UNITED STATES PATENT AND TRADEMARK OFFICE

10/023,474

Office Action Summary

DETAILED ACTION

attachment #1

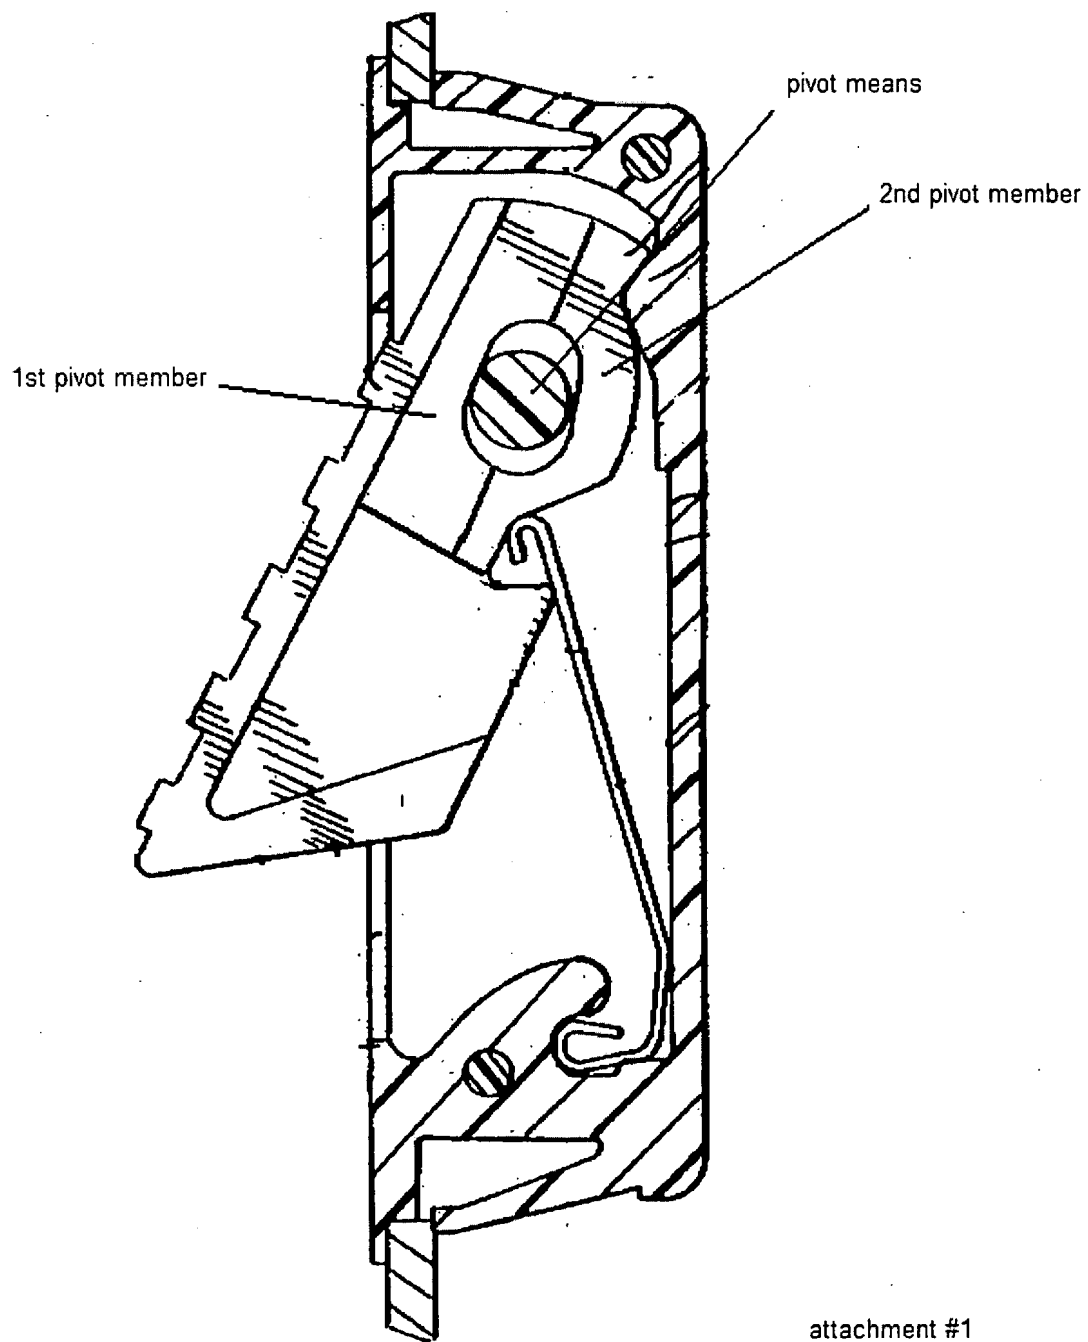
The tumbler further comprises a first pivot member that is capable of being in contact with the pivot means (38) when the tumbler is in the extended position (Figure 6, the opening contact the surface of 38), and a second pivot member that contact the bottom surface of the housing to prevent over travel of the tumbler (see attachment #1).
